**Marion County
Board of County Commissioners**

**ZONING SECTION STAFF REPORT
January 5, 2025
BOARD OF ADJUSTMENT PUBLIC HEARING**

Case Number	251001V
CDP-AR	33033
Type of Case	Variance to reduce front setback from 25' to 10' for an existing pole barn-style carport.
Owner	Joseph and Ellen Metivier
Applicant	Joseph Metivier
Street Address	13310 SW 51 st LN, Ocala
Parcel Number	3495-165-102
Property Size	1.16 acres
Future Land Use	Rural Land (RL)
Zoning Classification	Single Family Dwelling (R-1)
Overlay Zone/Scenic Area	Secondary Springs Protection Overlay Zone (SPOZ), Farmland Preservation
Project Planner	Cristina Franco, Zoning Technician I
Related Case(s)	Open Code Case 986287- Carport and electric for gate and garage door without the applicable permits.

Figure 4
Site Plan

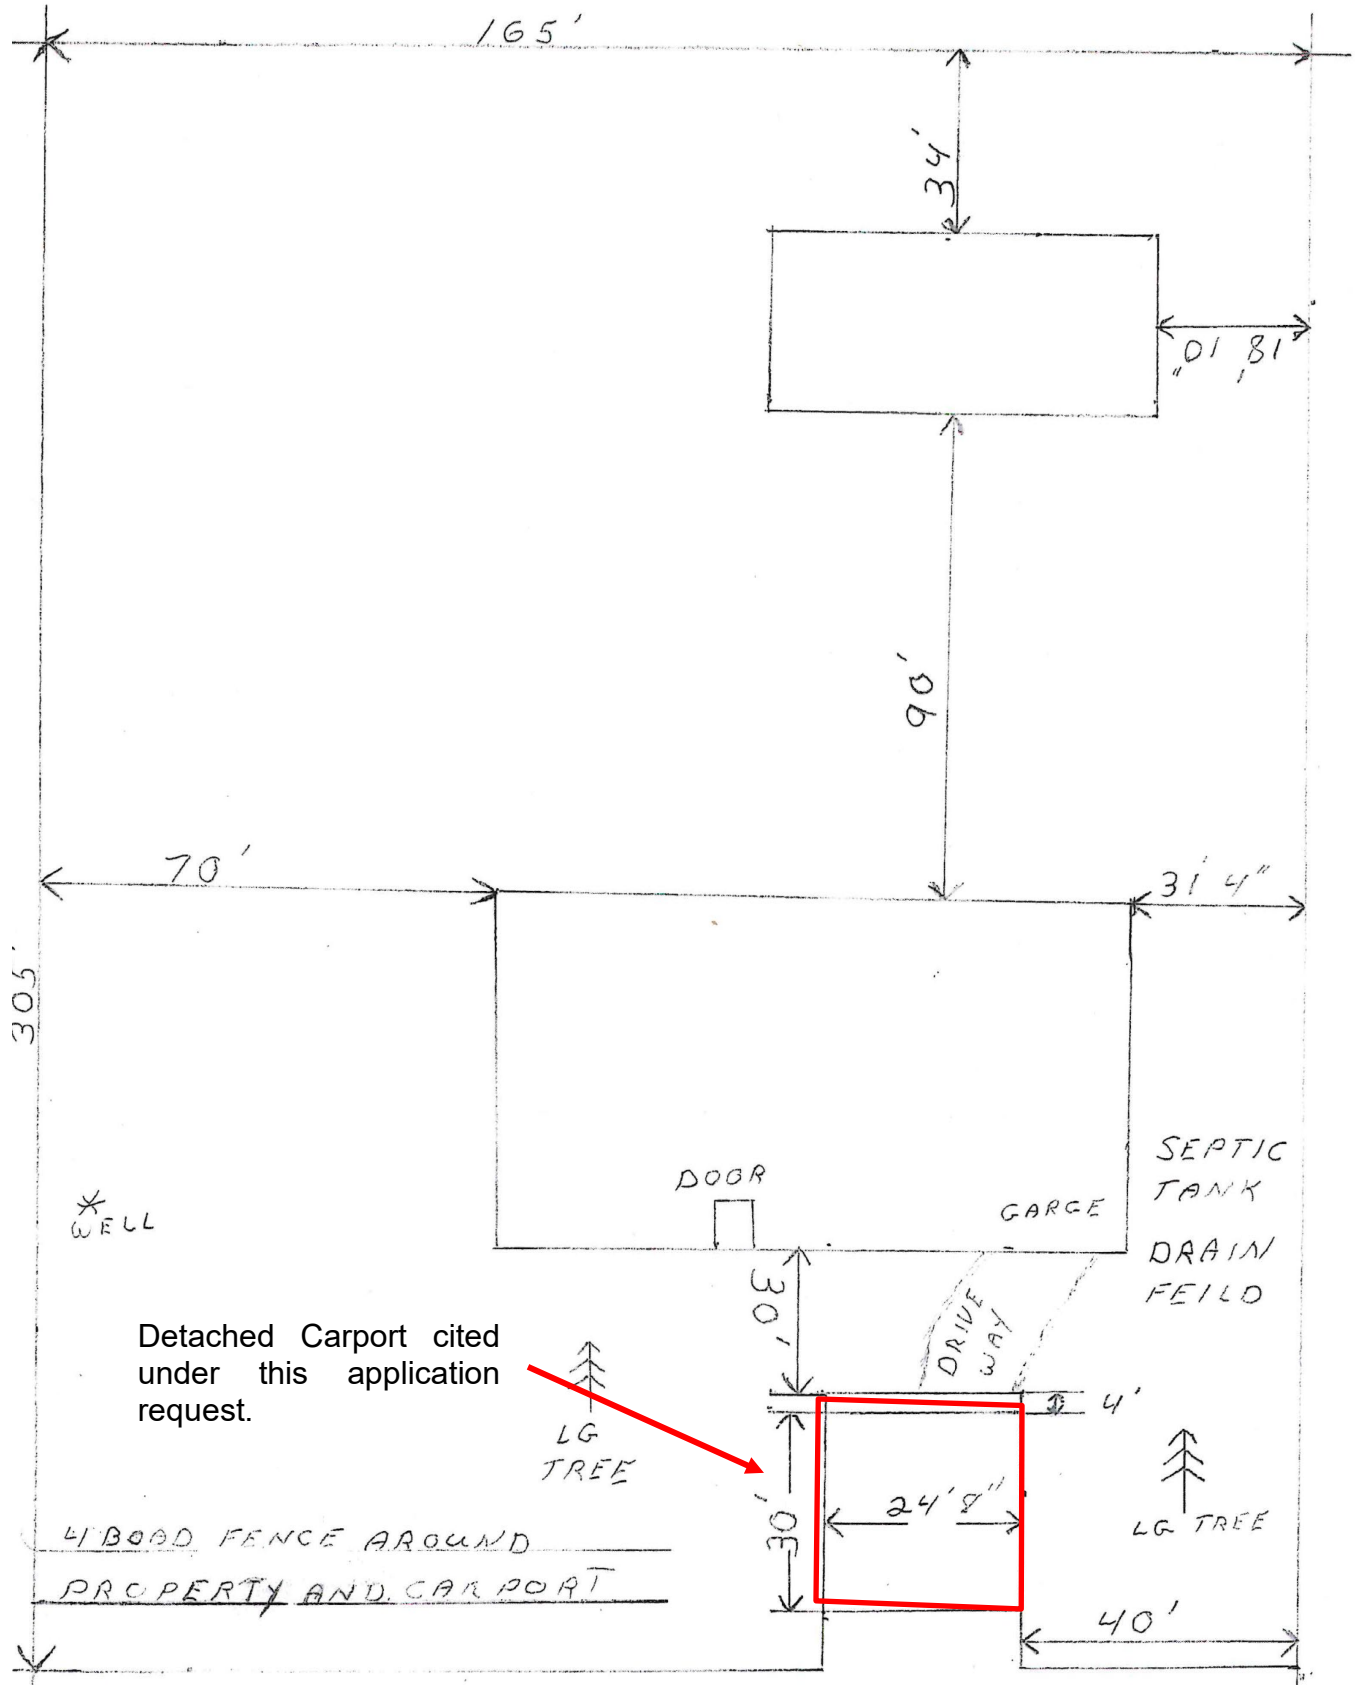
Staff finds that per the site plan provided, there is enough space on the side and rear of the property for an accessory structure, and would have enough space in the front of the property if the carport were attached to the home to meet the 25' front setback requirement for an attached carport. If homeowners had pulled the necessary permits, zoning would have denied them for the current location and also for not being attached to the house, as accessory structures are not allowed in front of an R-1 zoning classification.
